**MT. POLLEY MINE**

**N. ROSE GEOTECHNICAL INSPECTION OF OPEN PIT,**

**WASTE DUMPS AND TAILINGS DAMS**

**AUGUST 30, 2006**

FIG. 2  
MT. POLLEY  
AUG 30/2006

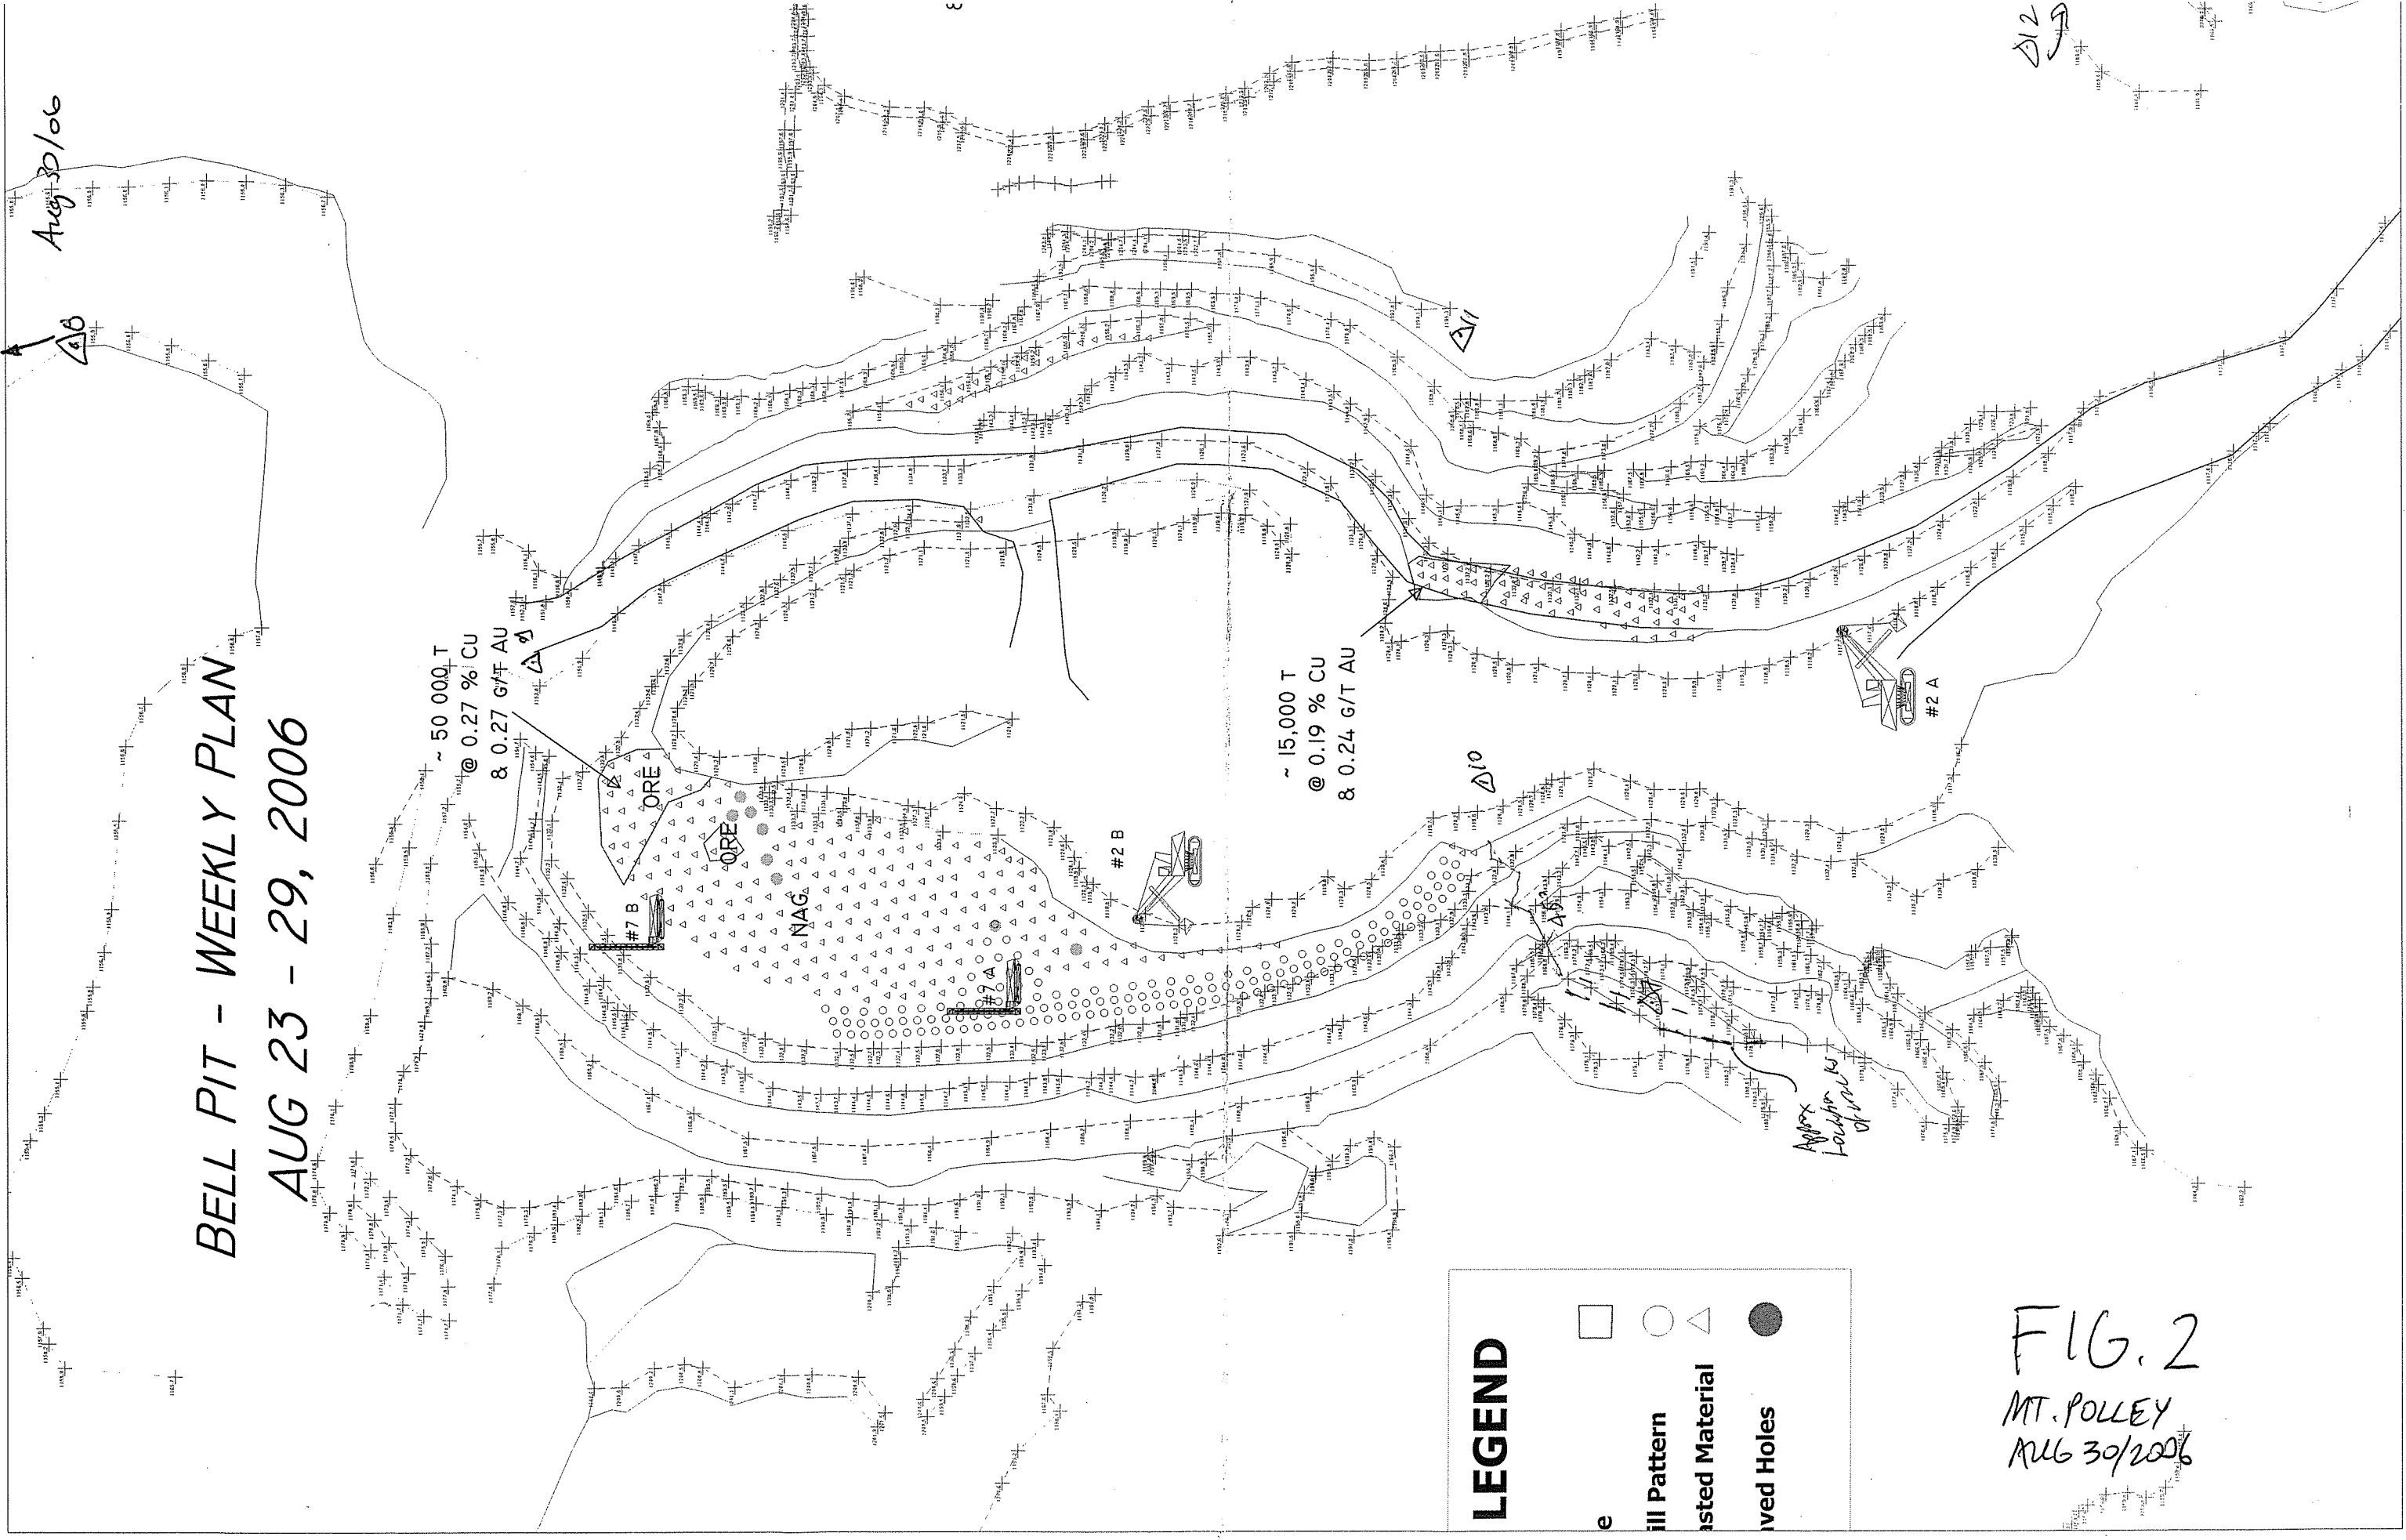
- Station 7:* Tension crack on west wall of Bell Pit. Maximum aperture 15cm, but generally 3 to 4 cm wide (see Fig. 2 plan map for estimated location). Continue to monitor prisms and visually inspect and mark crack locations on regular basis. Operations currently keeping equipment away from toe and inspecting while active in pit.  
View of east side of pit.

- Daily prism monitoring and assessment of monitoring data on west and east wall instability areas in the Bell Pit.
- Manual wireline extensometer and manual crack monitoring devices (e.g., rebar pins) could be used for manual monitoring in addition to prism surveys.
- A suitably sized rockfall impact barrier shall be placed on the north haulroad below the area of active instability if raveling or rockfall hazards develop on the haulroad
- Threshold monitoring movement rate and operational response criteria shall be developed for the west and east walls of the Bell Pit and submitted to the Ministry within 15 days of the receipt of this report.
- The recommendations made by the design consultant for remedial design changes shall be followed.
